CONSTRUCTION PLANS REVISION

County: Shelby

Project #: 79006-3190-14
PIN#: 100331.00

Description of Project: I-240

TYPE	YEAR	PROJECT NO.	SHEET NO.
R.O.W.	2008	NH-I-240-1(286)	41
CONST.	2010	STP-I-240(290)	61

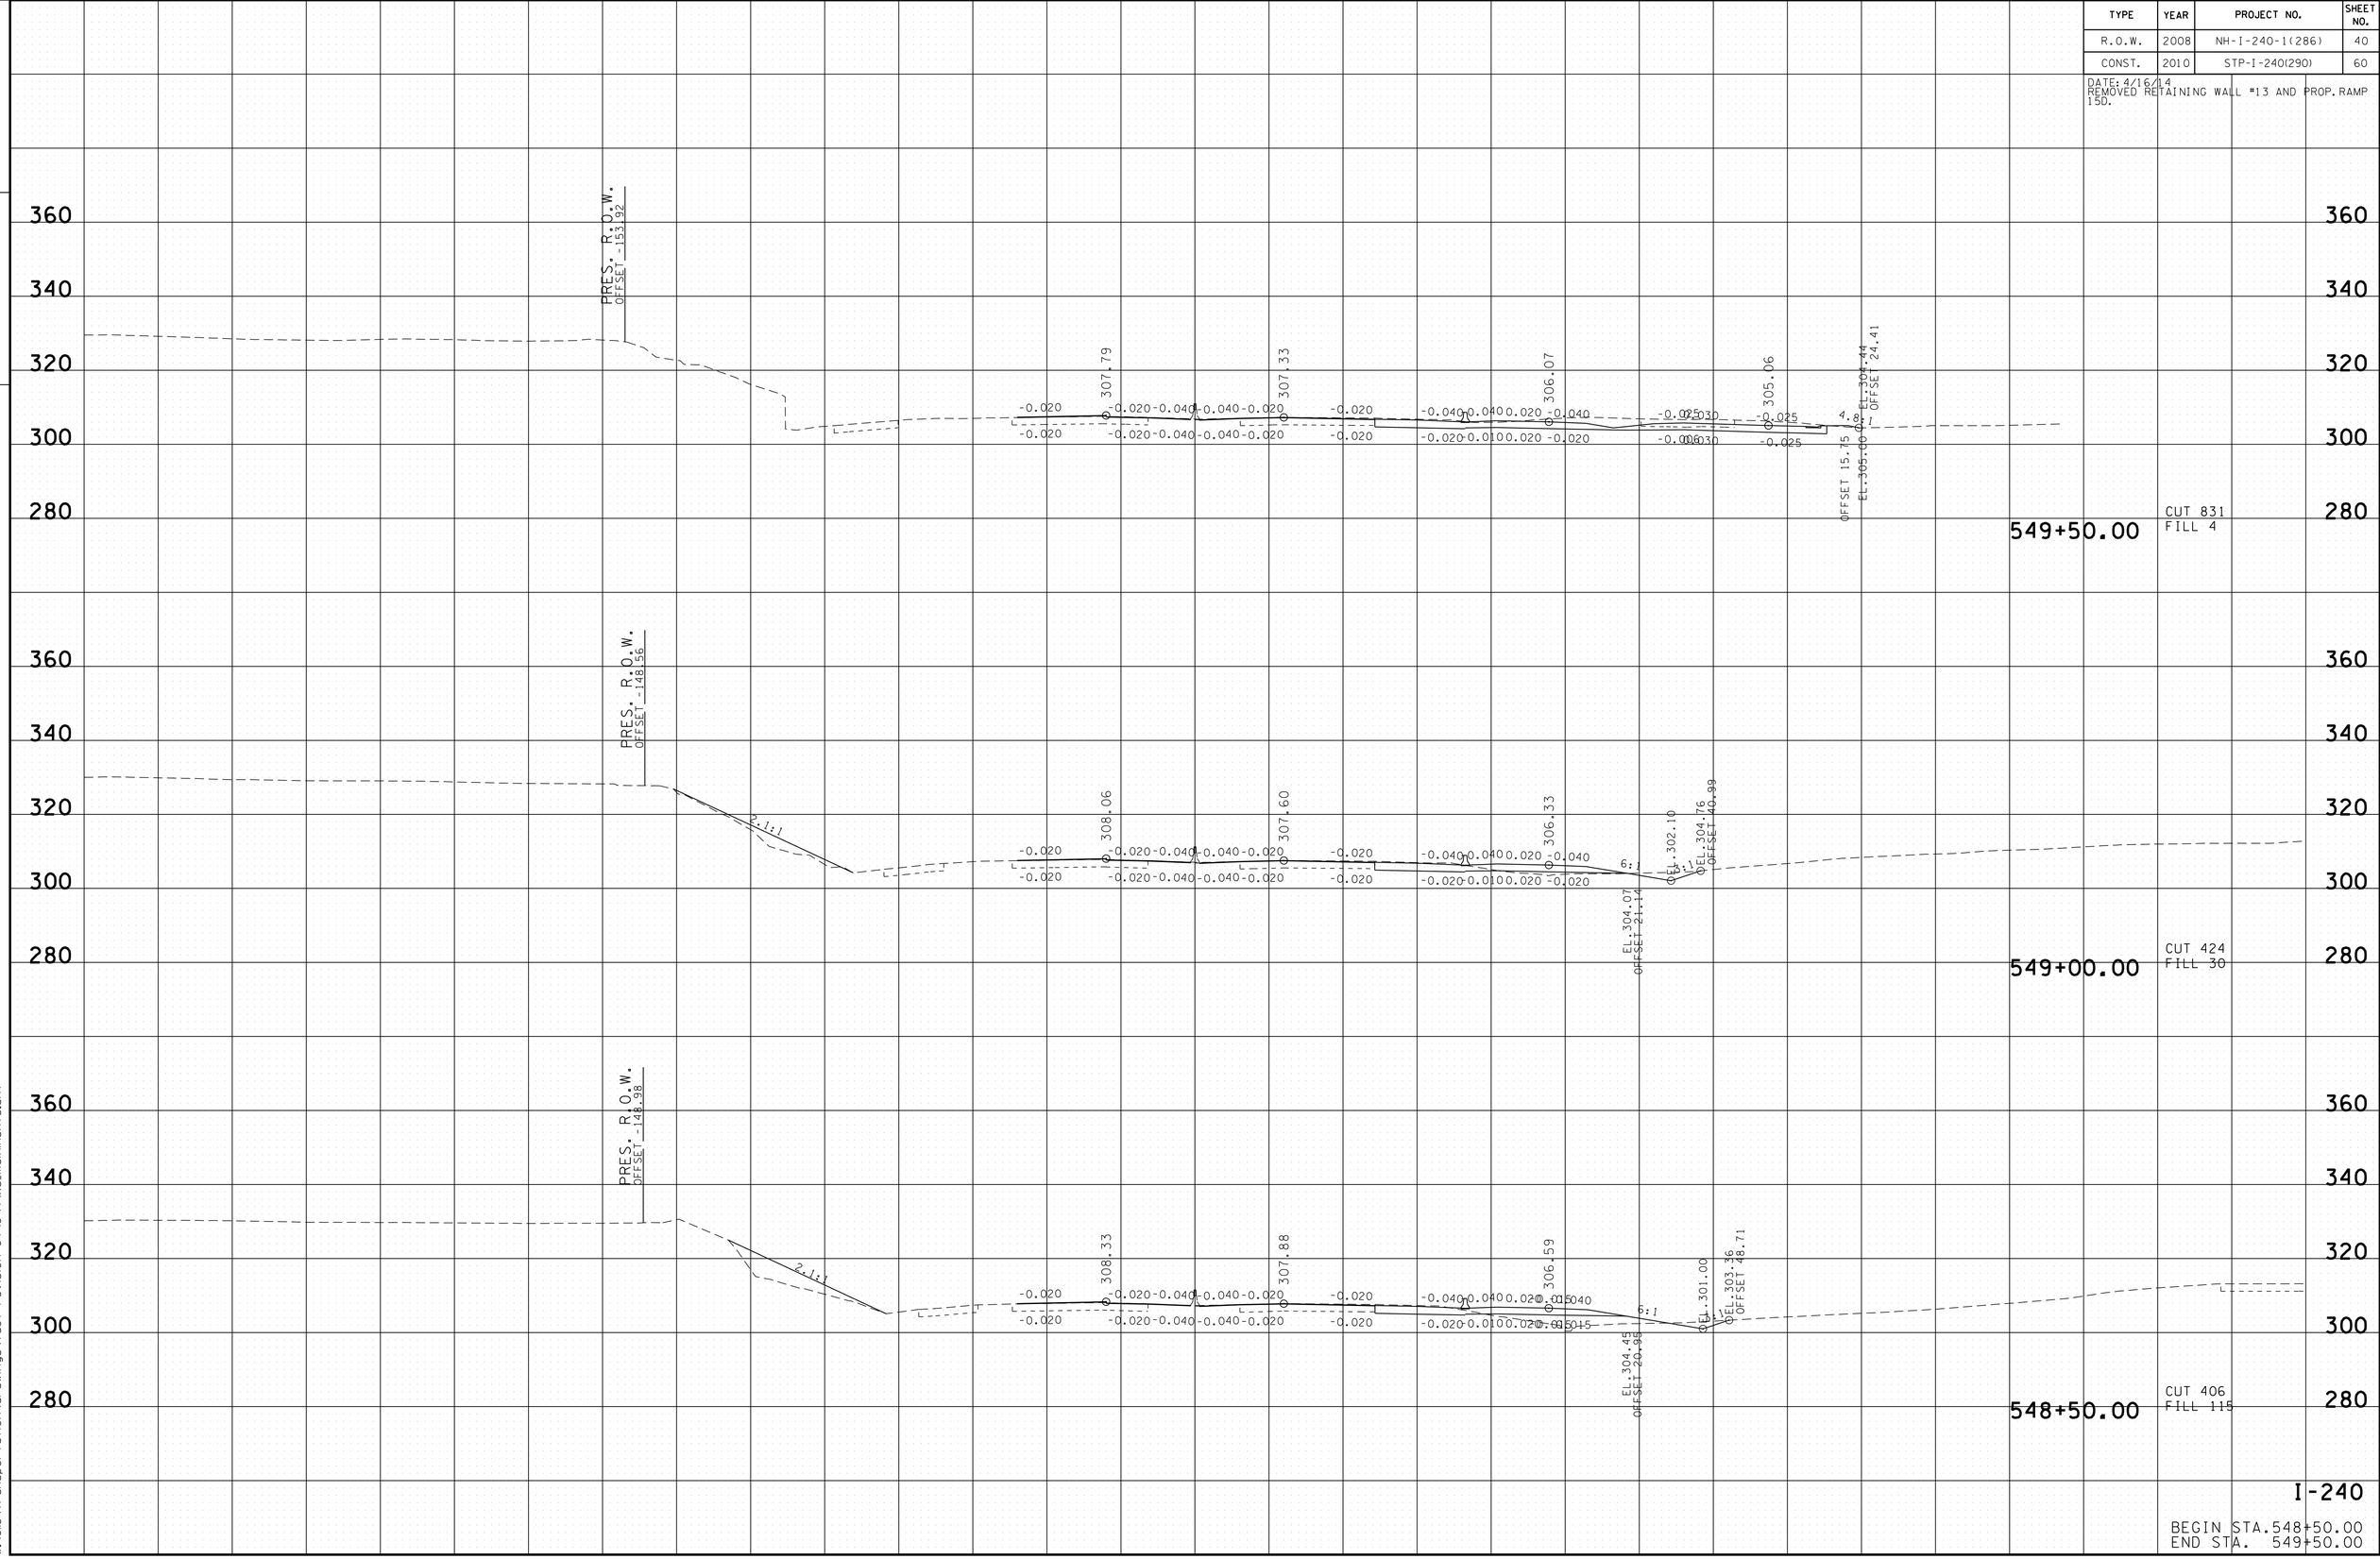
DATE: 4/16/14
REMOVED RETAINING WALL #13 AND PROP. RAMP 15D.

RAMP 15-D

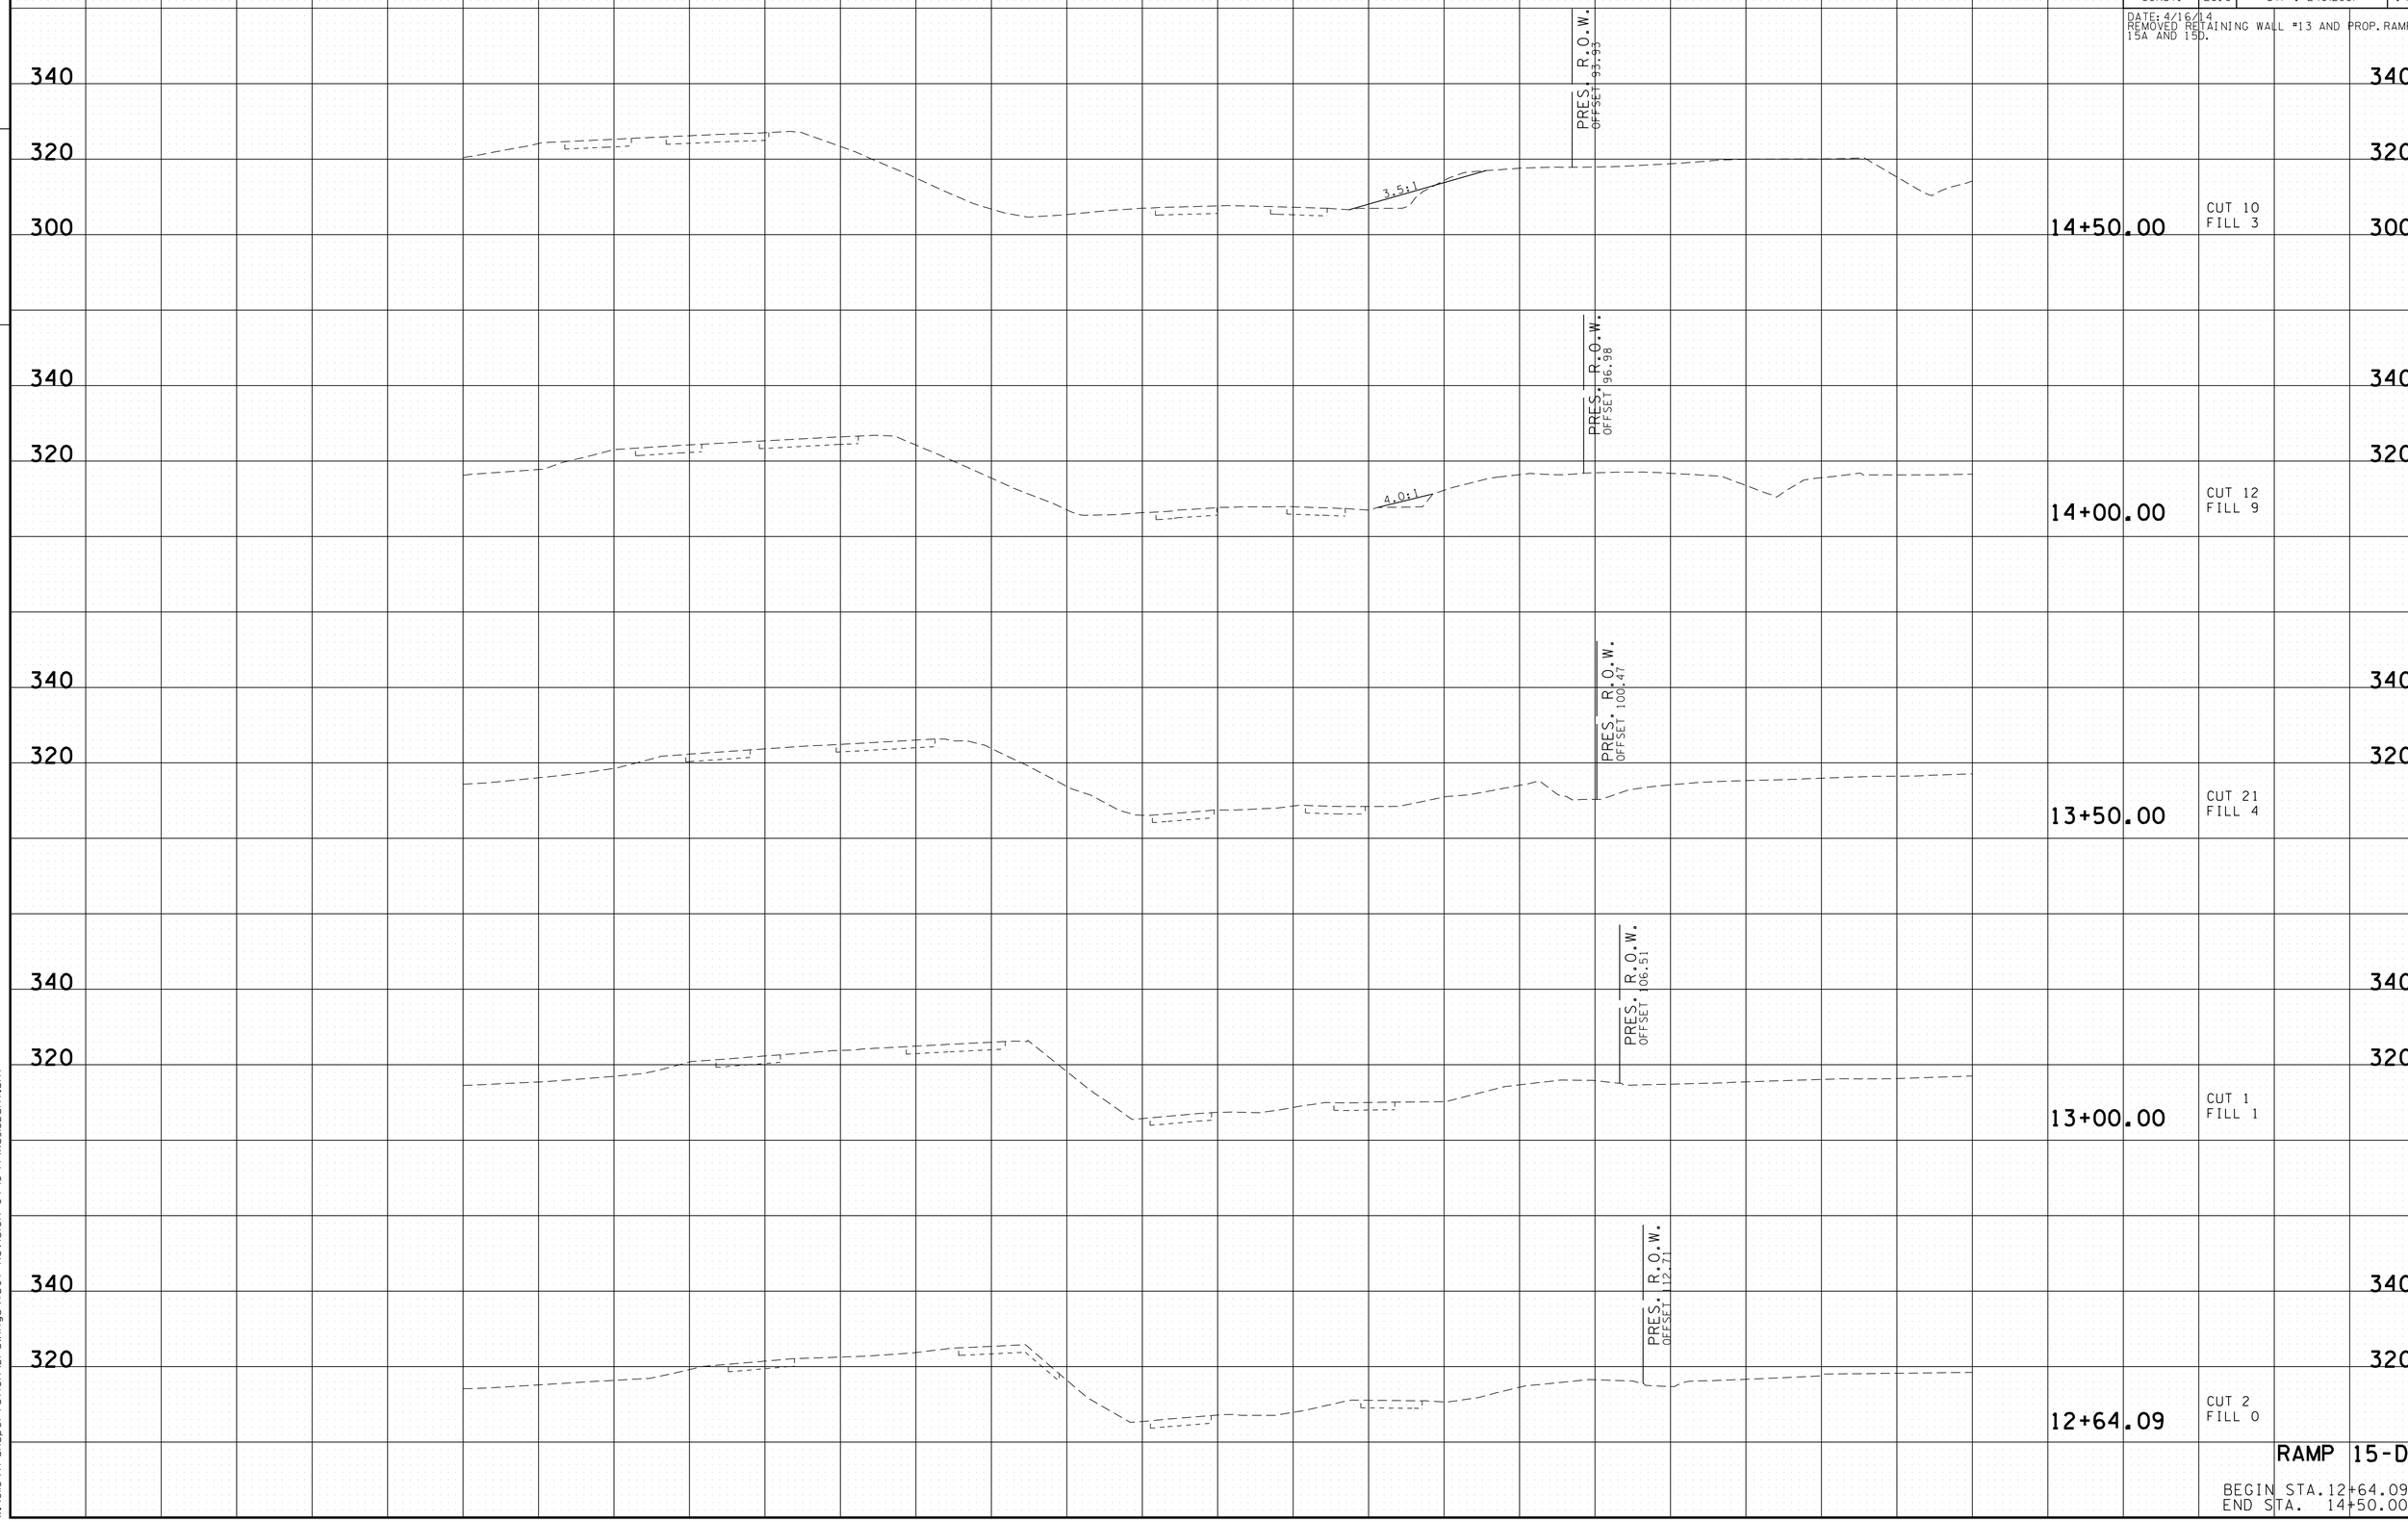
Description of Revision: Revision No. __. Revised typical sections to remove prop. 4th SB lane from between Sta. 547+74.89 to Sta. 551+13.01 and stations for Ramp 15A & 15D typical sections, sheets 2G & 2T. Revised tabulated quantities to remove prop. structures that will not be constructed on Ramp 15A and 15D, sheets 2CC, 2DD, 2GG & 2HH. Revised proposed layouts to show portion of mainline and Ramp 15A/D that will not be constructed – added temp. detour ramp that is to remain for future project, sheets 5A & 6B. Revised signing and pavement marking plan to eliminate southbound 4th lane, sheets 24-24D. Revised sign schedule to add additional signs needed for dropping 4th (outside) southbound lane, sheets 24-O & 24R. Revised cross sections to show elimination of portion of CD Road 1 and Ramp 15D, sheets 58-61 & 143-146.

TYPE	YEAR	PROJECT NO.	SHEET NO.
R.O.W.	2008	NH-I-240-1(286)	126
CONST.	2010	STP-I-240(290)	146

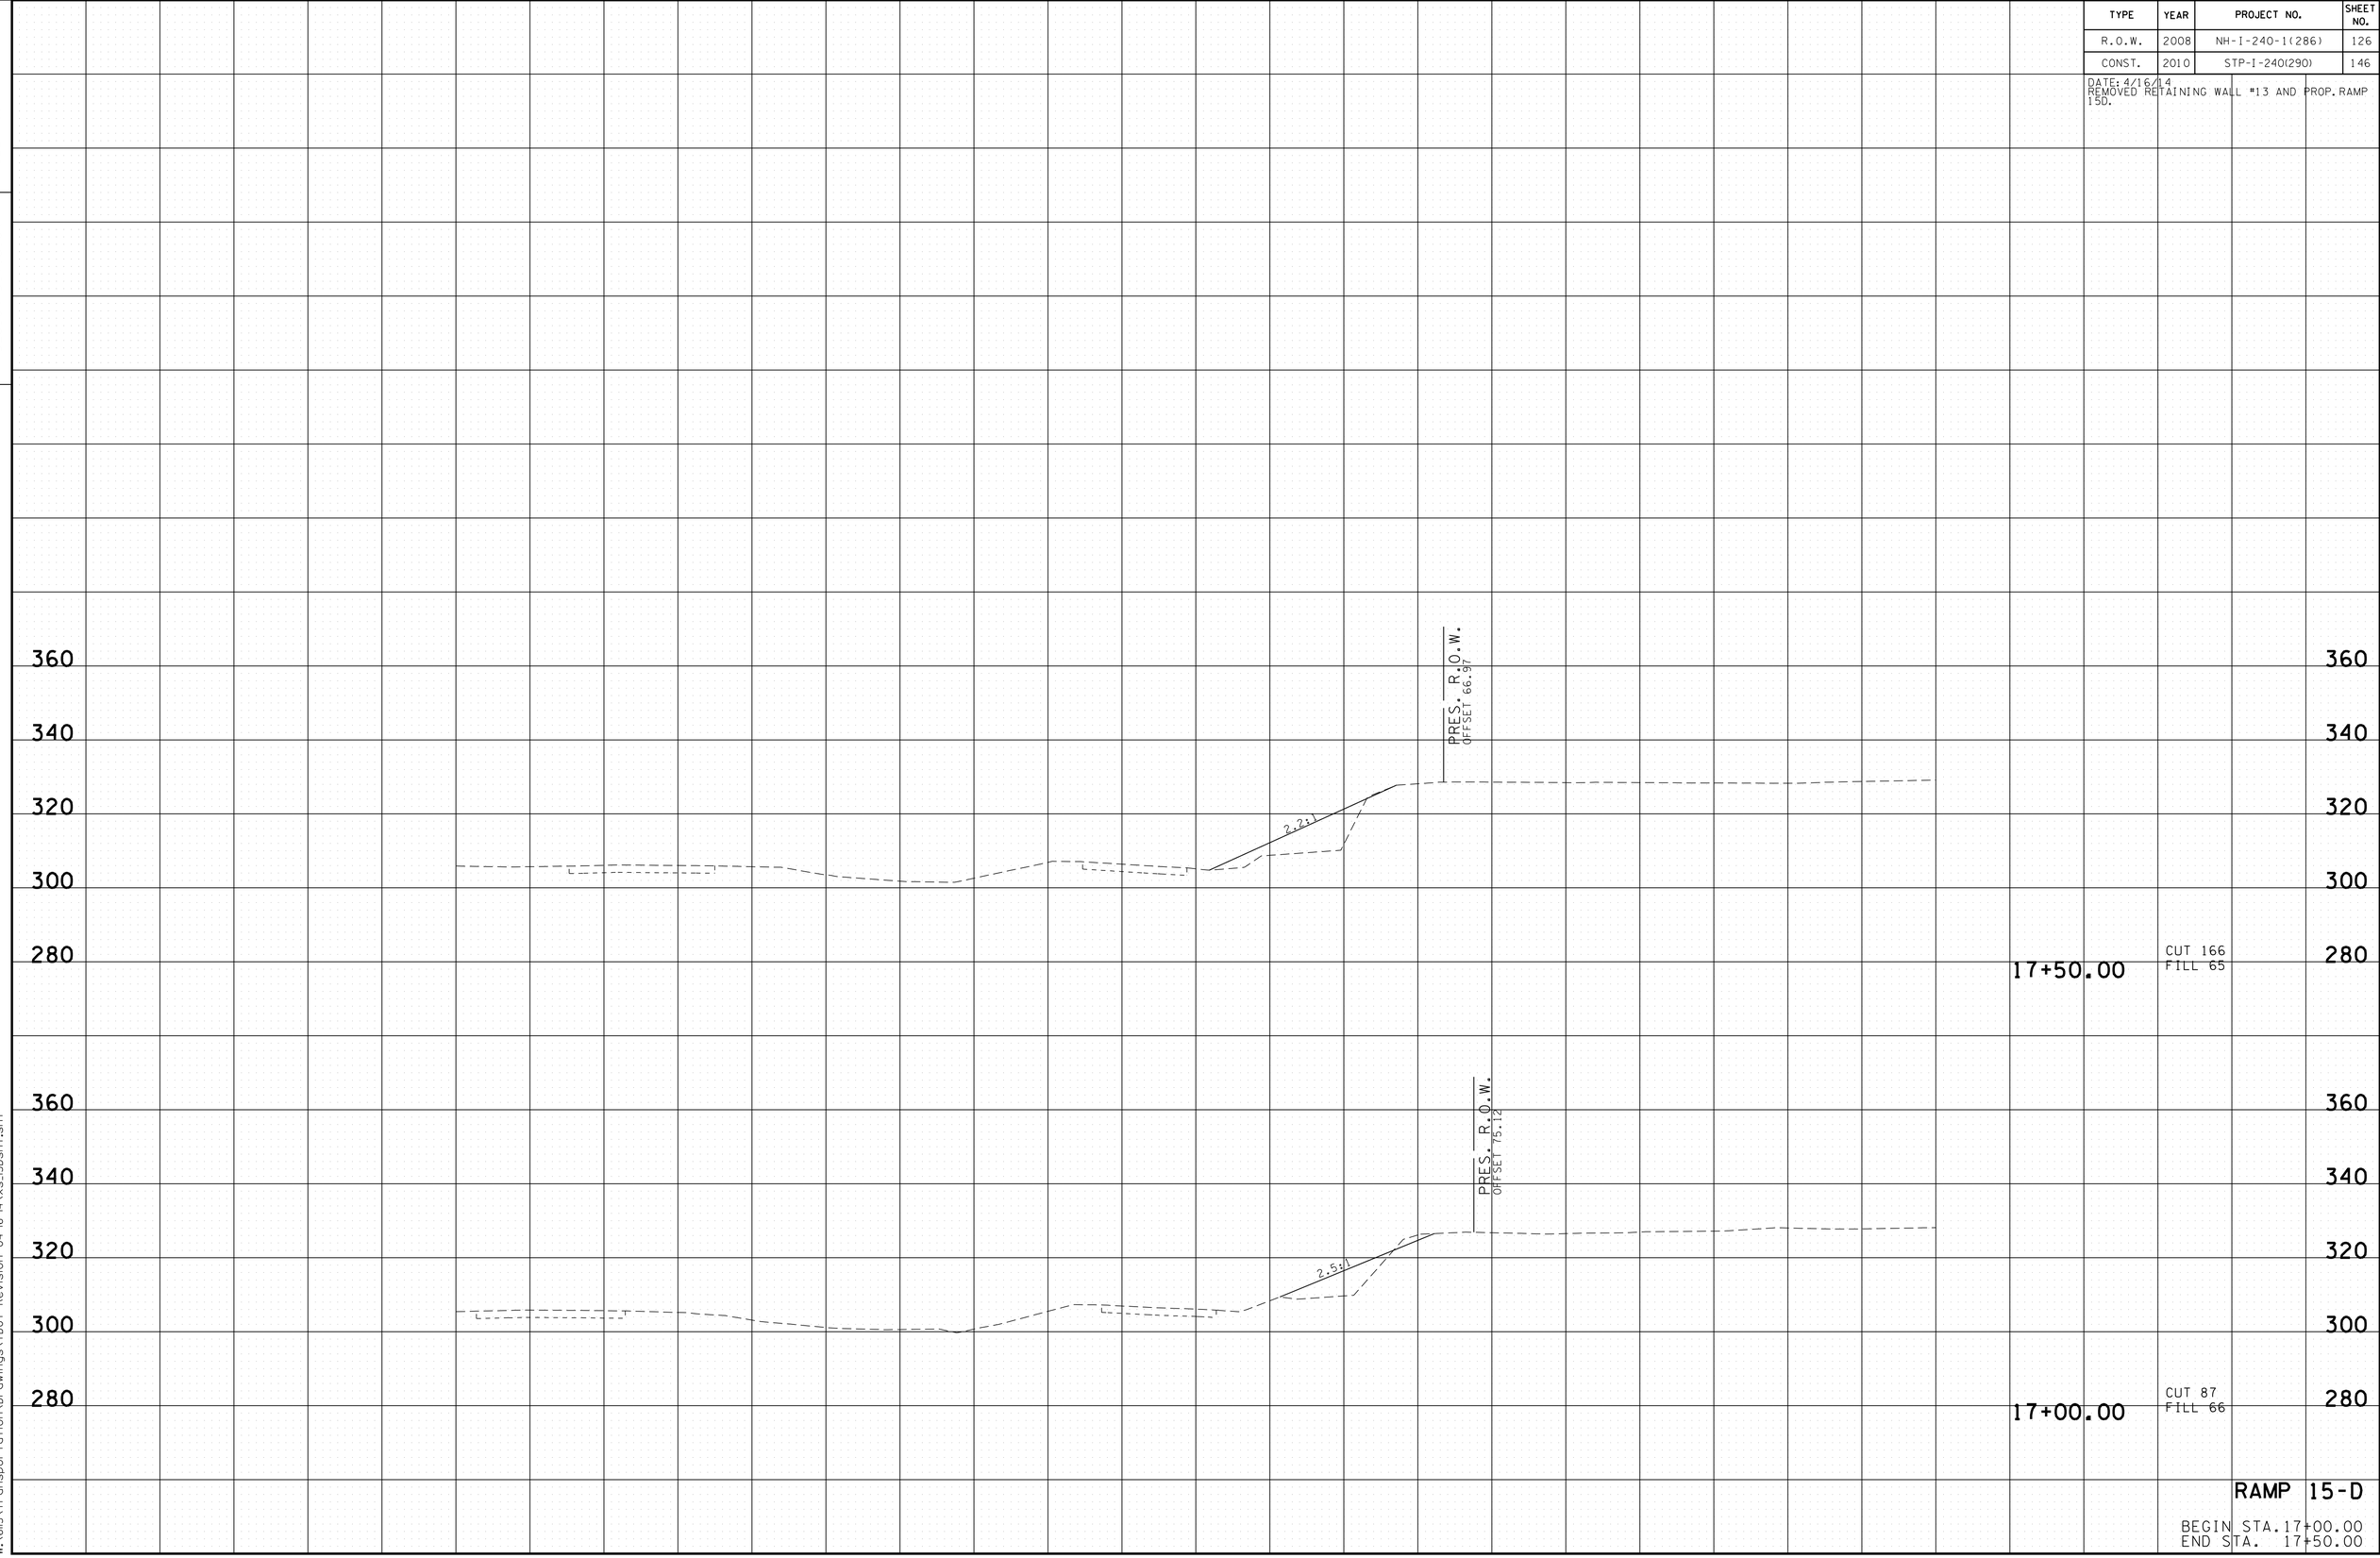
DATE: 4/16/14
REMOVED RETAINING WALL #13 AND PROP. RAMP 15D.
